PRODUCT/PROCESS CHANGE NOTICE (PCN)

PCN #: L-0607-01	DATE: 4-Aug-2006	MEANS OF DISTINGUISHING CHANGED DEVICES:
Product Affected: Please see the attached list of the affected products shipped in tape and reel and in tubes	☐ Product Mark	Lot shipments will have Level 1
Date Effective: 4-Aug-2006	☐ Back Mark	Moisture Sensitive Label, and with
	☒ Date Code	date code "0630".
	☐ Other

PCN Type: Change in Moisture Sensitivity Level

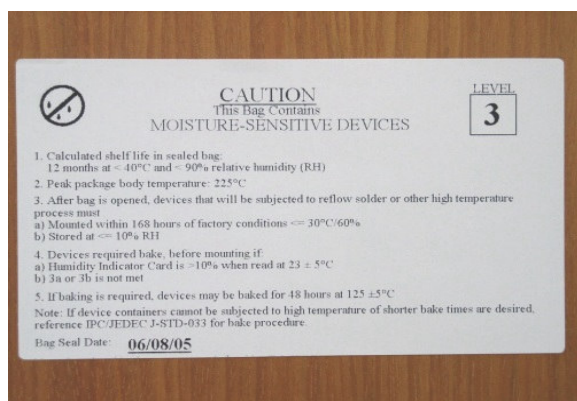
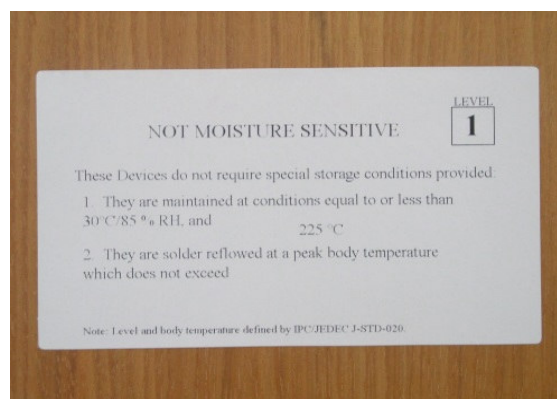
Data Sheet Change: There is change in Moisture Sensitive Level (MSL) from 3 to 1.

This notification is to advise customers that IDT is converting ICS MSL 3 products shipped in tape and reel, and in tubes, to MSL 1. IDT has completed the verification of the moisture sensitivity classification of ICS products to MSL 1.

The affected products will be shipped without dry pack and labelled as MSL 1 according the JEDEC J-STD-033. There is no change to the assembly material set and the peak reflow temperature. Please refer below for the examples of moisture sensitive labels.

From: MSL 3 Moisture Sensitive Label

To: MSL 1 Non-Moisture Label
